REQUEST FOR TENDER RFT #B25-03

Washroom Upgrades
(Fenelon Twp PS, Bobcaygeon PS, IE Weldon SS, Lady Mackenzie PS)

TLDSB ADDENDUM NO. 9

RFT B25-03
BOBCAYGEON PUBLIC
SCHOOL STAFF
WASHROOM

1 Rm 106 HALLWAY SOUTH
1:25

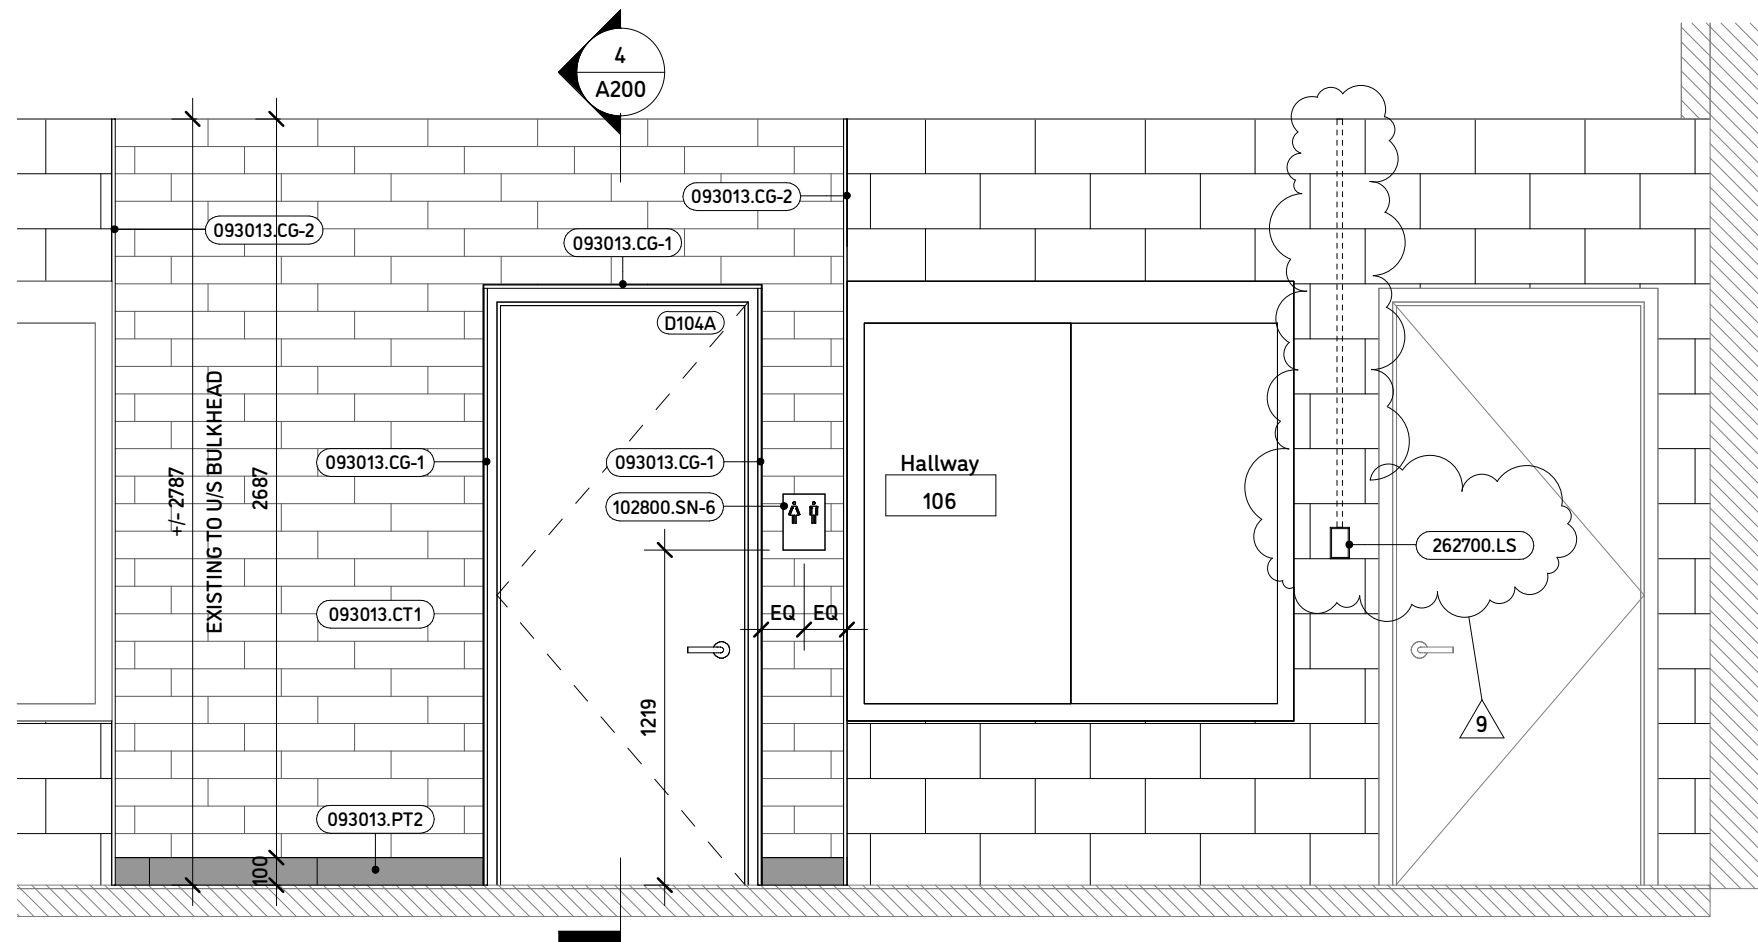
- 3.1 **Display Cabinet Light Switch. Refer to attached ASK 001 Rm 106 HALLWAY SOUTH for clarification of the location of the display cabinet lighting light switch. New wiring and switch is to be located in the nearest open concrete block core.**
- 3.2 **Revise Room Finish Schedule as follows:**
 - Office 104 Floor Finish: RF-1 Resilient Sheet Flooring.**
 - New RB Rubber Base remains the same.**
- 3.3 **Include in bid for full replacement of the ceiling in both of the new rooms.**
Replacement assembly for both rooms as follows:
 - 16mm "Mold Tough" moisture resistant gypsum board.**
 - 92mm 22ga steel studs @ 400mm c/c**
